# UNITED STATES PATENT AND TRADEMARK OFFICE

10/543,029

PAYER, HWEI SIU CHOU

## Detailed Action

fig.4

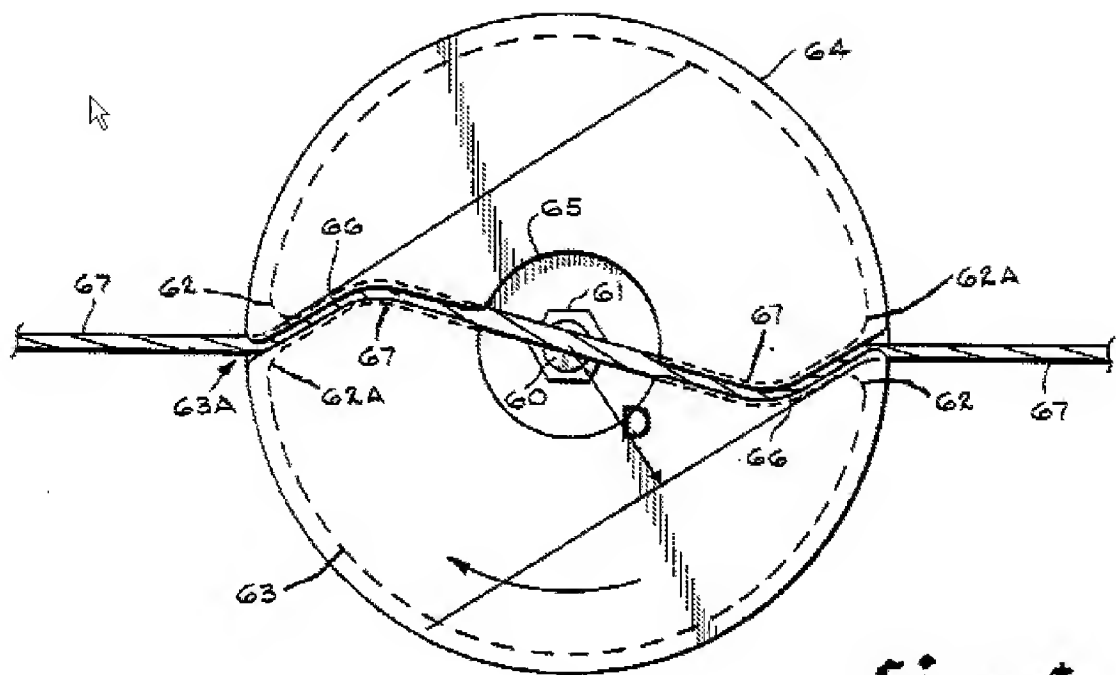
In response to Applicant's argument regarding the Morabit et al. reference, it is noted the reference to be modified is "Ballas et al." not "Morabit et al.". In Ballas et al., the inner edge (i.e. the portion of the passageway 66 within which the cutter string 67 is received) of the passageway (66) engages the trailing edge of the string as claimed.

In response to Applicant's argument with respect to "Moore", it is Ballas et al. that is to be modified not the "Moore" reference. Ballas et al. as modified shows "the passageway extends along an axis that is spaced a distance (D) from an axis of rotation of the head" as claimed. See the following illustration.
